**Buildings to be Planned for Use by Persons with a Disability
Regulation 72 of Building (Planning) Regulations
Design Manual: Barrier Free Access 2008**

Amendments to the Design Manual: Barrier Free Access 2008

(November 2012)

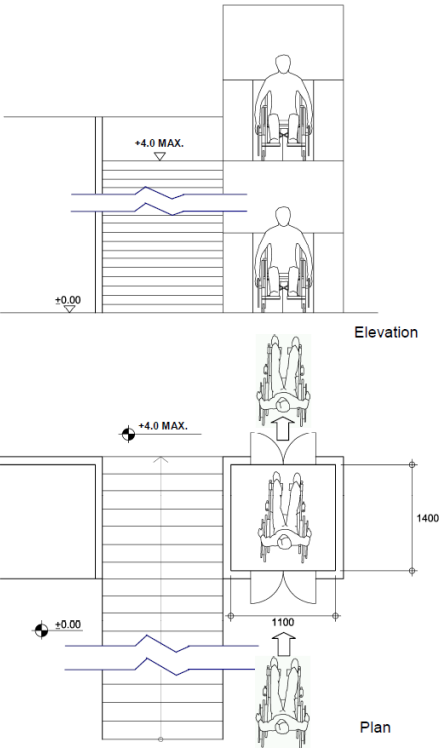
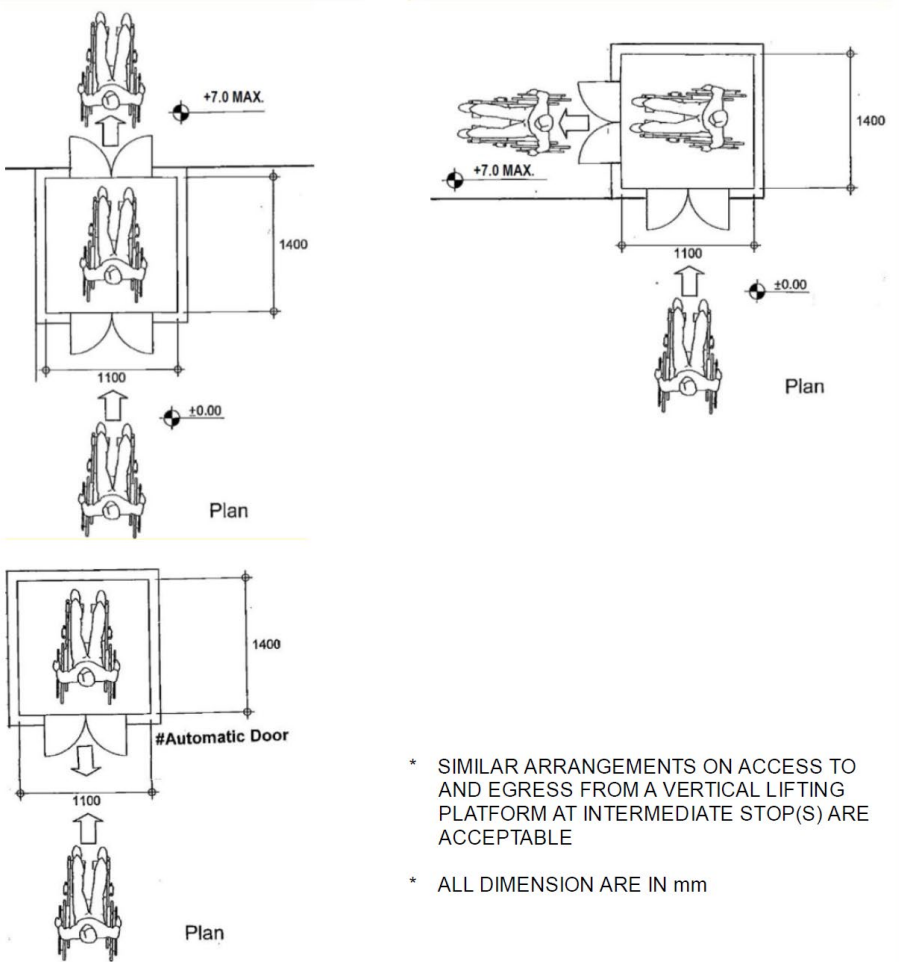
Item	2008 version	Amendments
5. Figure 45	 <p data-bbox="537 989 705 1005">*ALL DIMENSIONS ARE IN mm</p> <p data-bbox="577 1037 817 1053">Figure 45 – Vertical Lifting Platform</p>	 <p data-bbox="1601 965 2072 1061">* SIMILAR ARRANGEMENTS ON ACCESS TO AND EGRESS FROM A VERTICAL LIFTING PLATFORM AT INTERMEDIATE STOP(S) ARE ACCEPTABLE</p> <p data-bbox="1601 1085 1904 1109">* ALL DIMENSION ARE IN mm</p> <p data-bbox="1422 1220 1825 1252">Figure 45 – Vertical Lifting Platform</p>

1. Figure 16A@

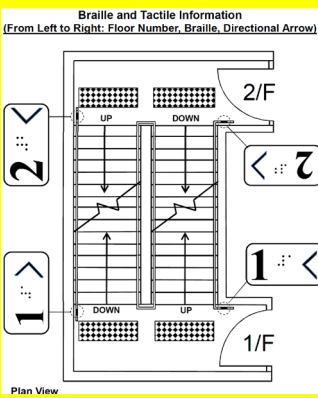
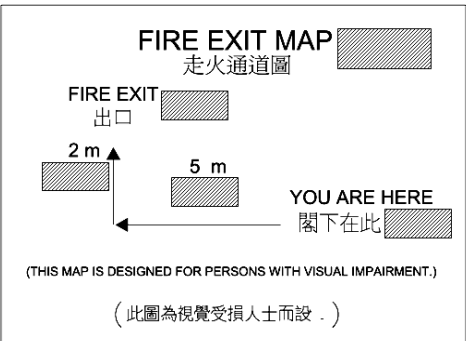
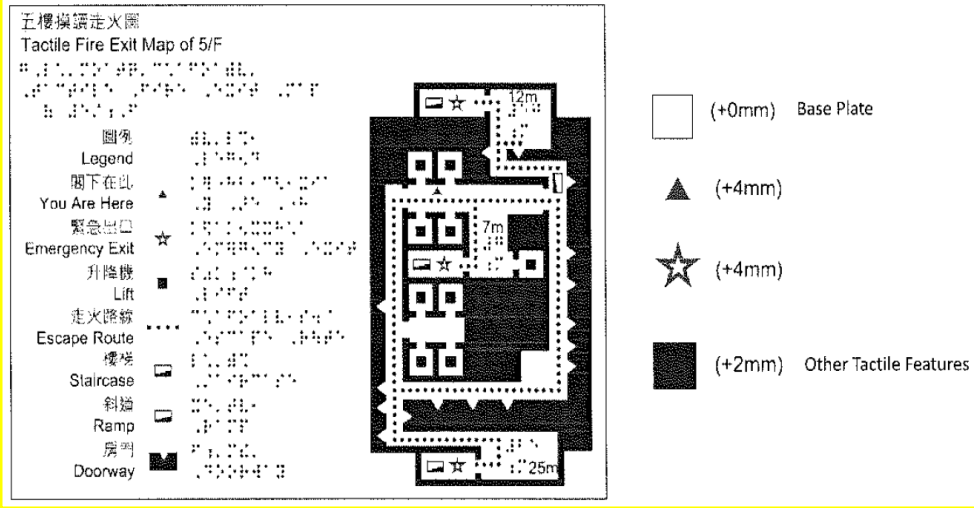
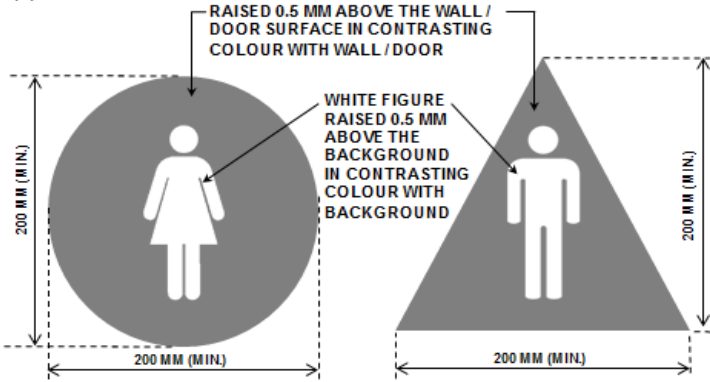
Figure 16A – Handrails of Staircase

Figure 32A – Example of Braille and Tactile Plan of Toilet and Changing Room

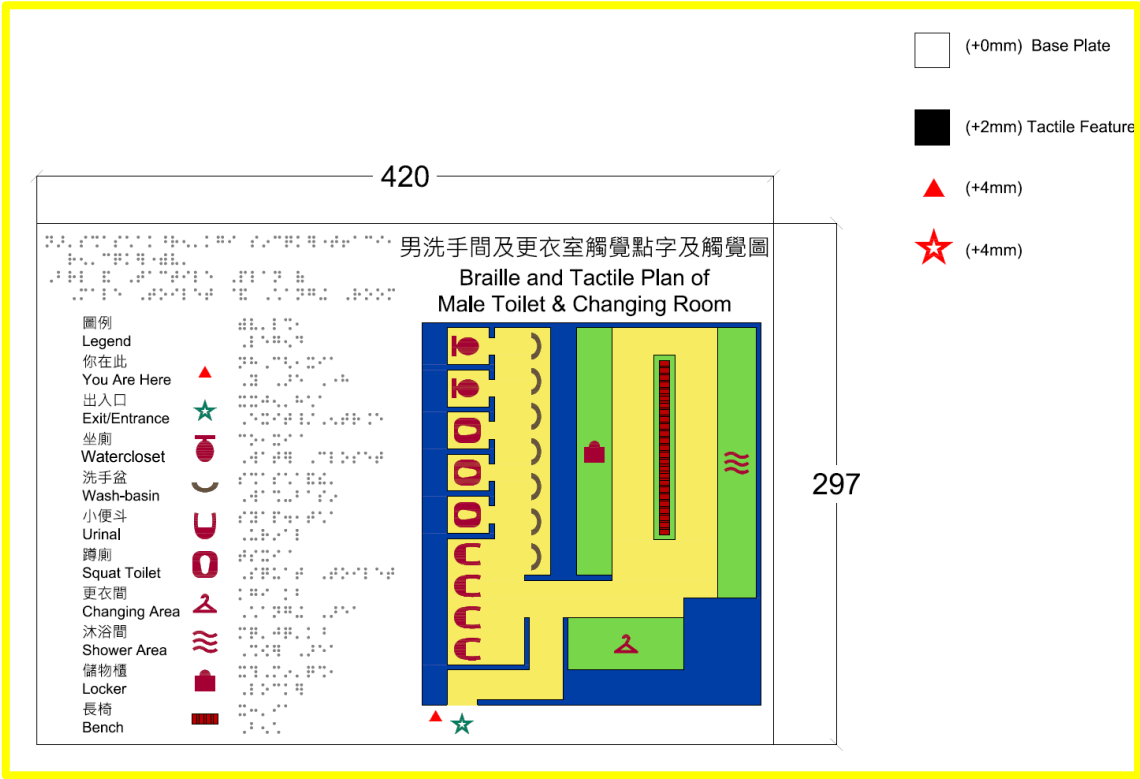
Item	2019 version	Amendments
8. Division 13 of Chapter 4##*	<p>BEST PRACTICE SECTION</p> <p>A. Design Considerations</p> <p>Persons with visual impairment may have difficulty in identifying their lockers for public use.</p> <p>B. Recommended Design Requirements</p> <p>Each locker door in sports complex, public swimming pool complex or public areas should be provided with Braille cells and raised Arabic numerals/characters*.</p> <p>* The locker key holders should be provided with raised Arabic numerals/characters.</p>	<p>BEST PRACTICE SECTION</p> <p>A. Design Considerations</p> <p>Persons with visual impairment may have difficulty in identifying their locker for public use, and sanitary fitments in a public toilet or changing room.</p> <p>B. Recommended Design Requirements</p> <p>(a) Each locker door in a sports complex, public swimming pool complex or public area should be provided with the locker number in Braille and raised Arabic numerals/characters*.</p> <p>* The locker key holders should be provided with raised Arabic numerals/characters.</p> <p>(b) A Braille and tactile plan (see Figure 32A) should be provided for the toilets with five or more waterclosets (urinal in a public male toilet and changing room is regarded as a watercloset for this purpose) in a public toilet/changing room. The plan should be installed on the wall adjacent to the door of the public toilet/changing room, or their entrance if entrance door is not provided. The plan should be placed at 900 mm to 1500 mm above the finished floor level.</p>

Item	2019 version	Amendments
		 <p>The diagram shows a floor plan of a male toilet and changing room. It includes a legend with Braille and English labels for various facilities: Legend, You Are Here (red triangle), Exit/Entrance (green star), Watercloset (red circle), Wash-basin (brown U-shape), Urinal (red U-shape), Squat Toilet (red circle), Changing Area (red triangle), Shower Area (blue wavy lines), Locker (red square), and Bench (red rectangle). The plan also features dimensions of 420 and 297, and a title in both Chinese and English: '男洗手間及更衣室觸覺點字及觸覺圖' and 'Braille and Tactile Plan of Male Toilet & Changing Room'. A legend on the right specifies tactile feature heights: (+0mm) Base Plate, (+2mm) Tactile Feature, (+4mm) Red Triangle, and (+4mm) Red Star.</p>
